#### 53B6 UPDATE - Drain Valve (NVLW)

August 13, 2013

# Technical Service Bulletin

Figure 2. Red arrows indicate excess underseal.

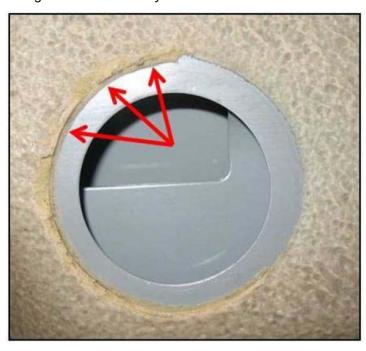
3. Remove any excess underseal (Figure 2).
